# CROSSROADS MIXED USE FILING NO. 1

## COUNTY OF EL PASO, STATE OF COLORADO STORM SEWER PLANS

UNDERGROUND DETENTION  
DECEMBER 2022

CROSS ROAD MIXED USE FILING NO.1		TITLE SHEET		DATE: 12-23-22		SHEET 1 OF 6		SI01	
PROJECT NO. 18-003		SCALE: HORIZONTAL: N/A VERTICAL: N/A		DESIGNED BY: GT		DRAWN BY: TAU		CHECKED BY: VAS	
212 N. WAHSATCH AVE., STE 305 COLORADO SPRINGS, CO 80903 PHONE: 719.955.5485									
FOR AND ON BEHALF OF M&S CIVIL CONSULTANTS, INC.		VIRGIL A. SANCHEZ, COLORADO P.E. NO. 37160							
REVISED:	NO.	DATE:	BY:	DESCRIPTION:	DATE:	BY:	DESCRIPTION:	DATE:	BY:
THE ENGINEER PREPARING THESE PLANS WILL NOT BE RESPONSIBLE, OR LIABLE FOR, UNAUTHORIZED CHANGES TO OR USES OF THESE PLANS. ALL CHANGES TO THE PLANS MUST BE IN WRITING AND MUST BE APPROVED BY THE PREPARER OF THESE PLANS.									
CAUTION

# ACCEPTABLE FILL MATERIALS: STORMTECH MC-7200 CHAMBER SYSTEMS

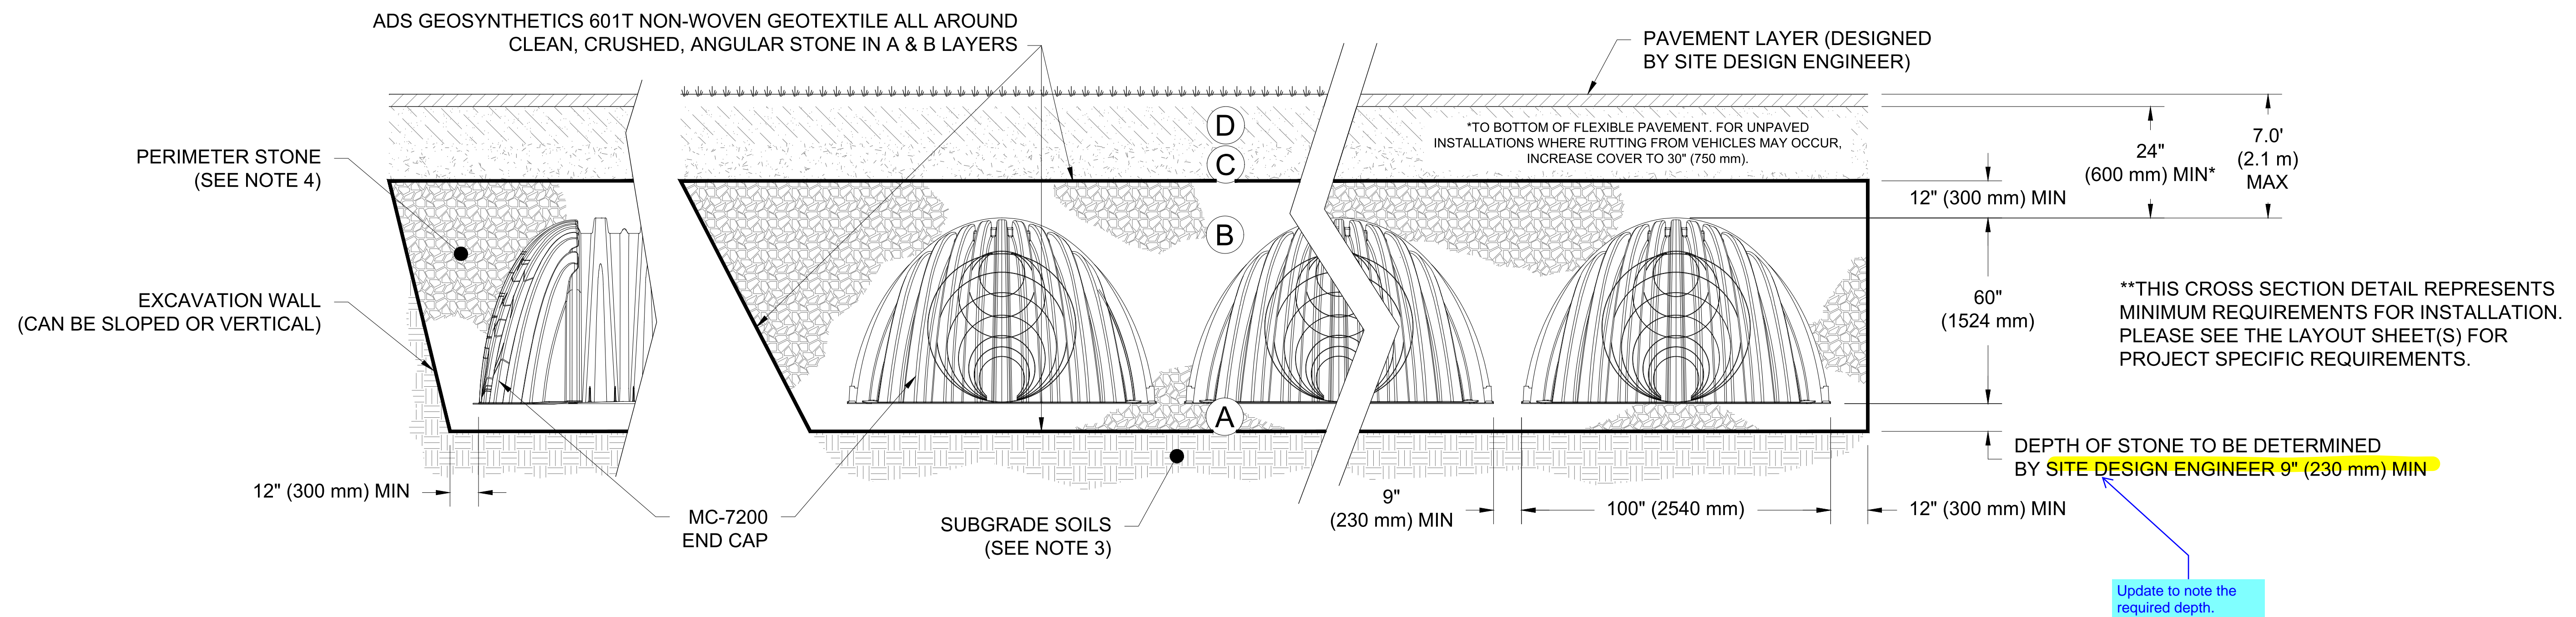
The plans needs to be updated to reflect the required base stone depth.

SECTION B-B

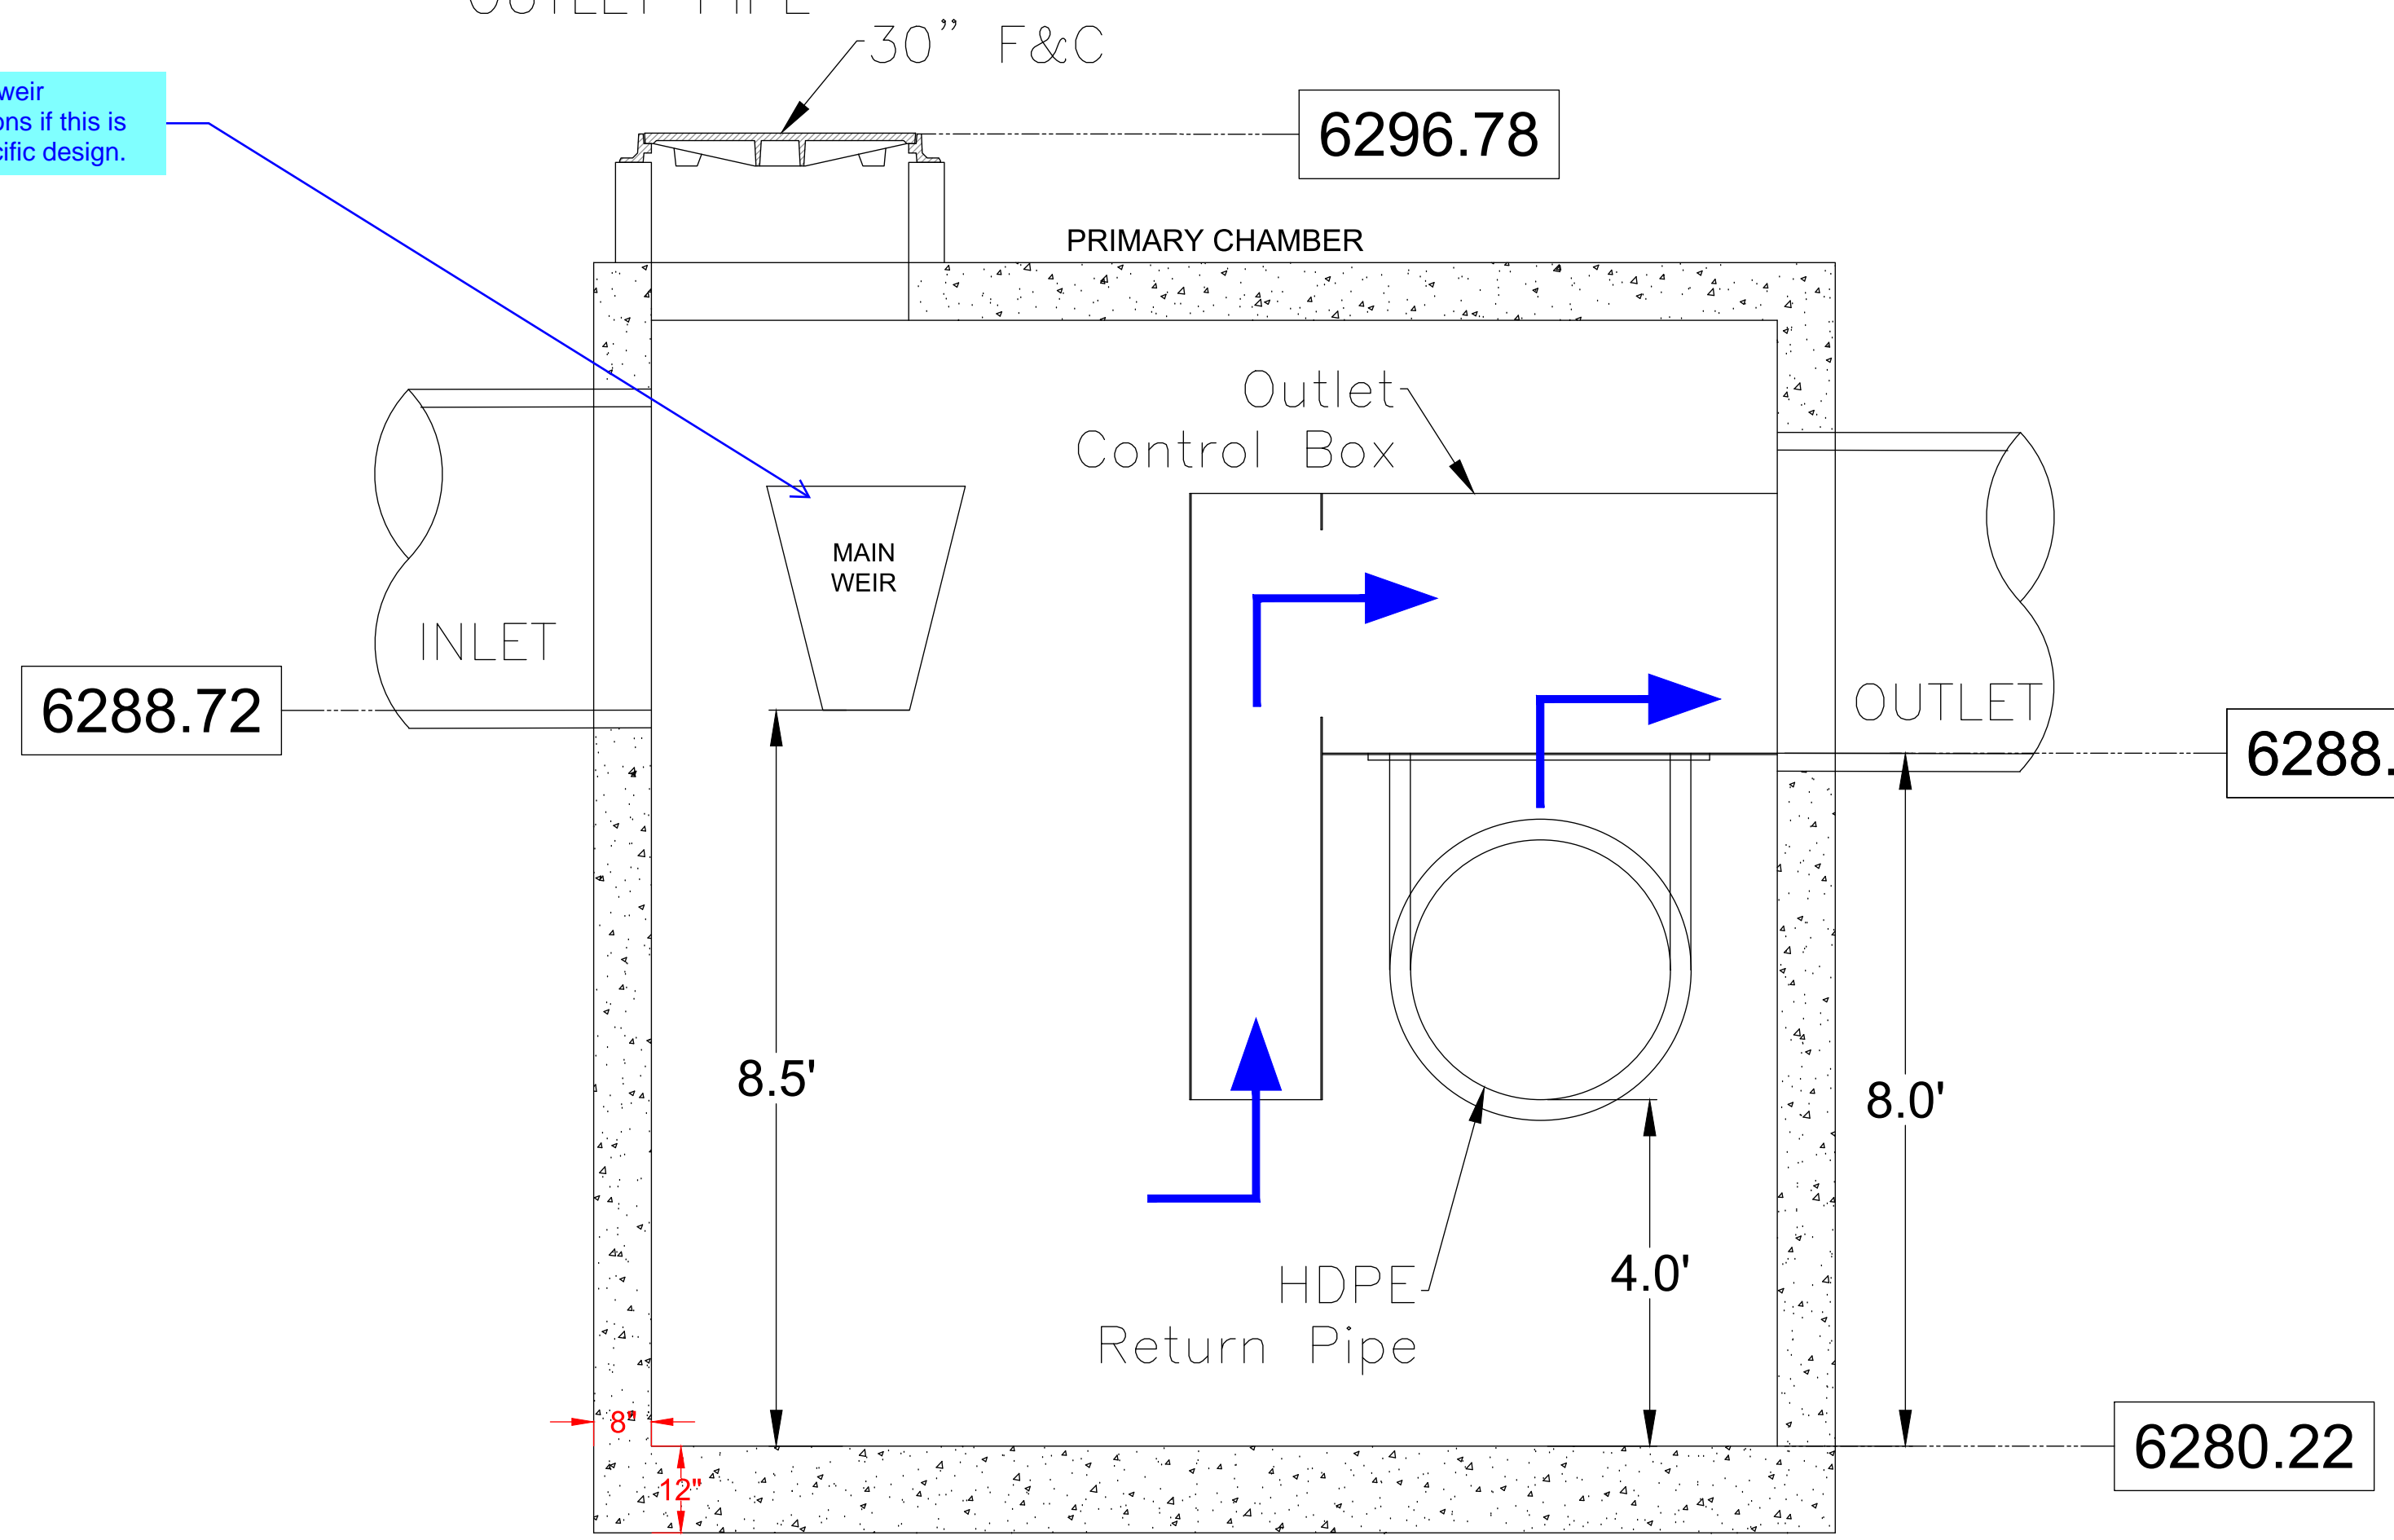
Provide and show the location and details for the steps to access the interior of the structure.

Provide clarification in the drainage report.  
 The summary table notes 65.5 cfs peak flow rate which is less than the anticipated 100yr flowrates going into the bayseparator. This would backup the stormwater upstream of the Bayseparator. Should the peak flow rate be increased to match the inflow? Does the increase affect the TSS rate?

Provide weir dimensions if this is site specific design.
